Product Change Notification

Business Unit	Product Line Code	Type of Change	Action	Date of Issue
AI - Automation Infrastructure	DNA	Product Change Notification	Notify Distributors and Field	1/18/2023

Part #	Type Description
2702382	PSR-MC82-5NO-1NC-1DO-24DC-SC
2702383	PSR-MC82-5NO-1NC-1DO-24DC-SP

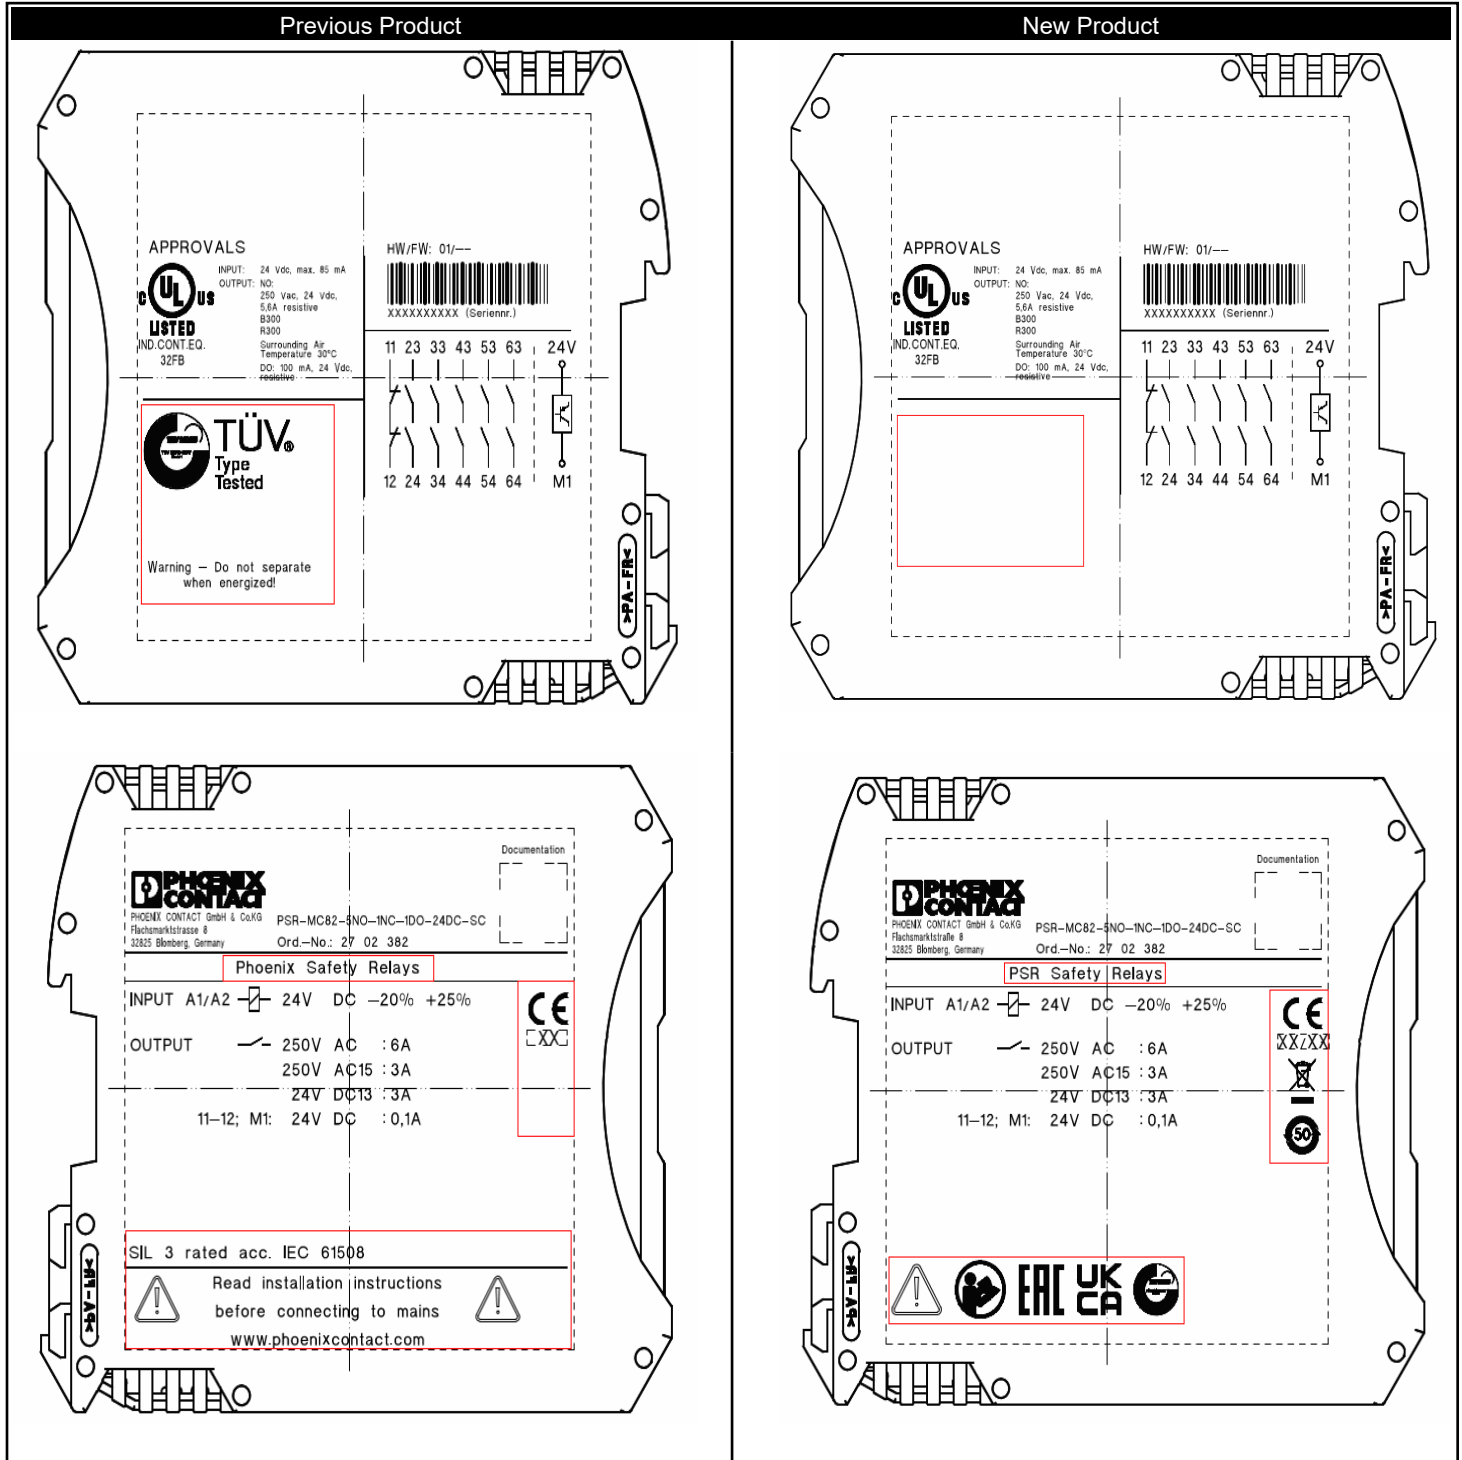
In addition to the year of manufacture, the calendar week will also be displayed below the CE mark. The various pictograms and TÜV approvals will be displayed in the lower area on the left half of the housing. The connectors will no longer be coded and the color will change from green to light gray (RAL 7035).
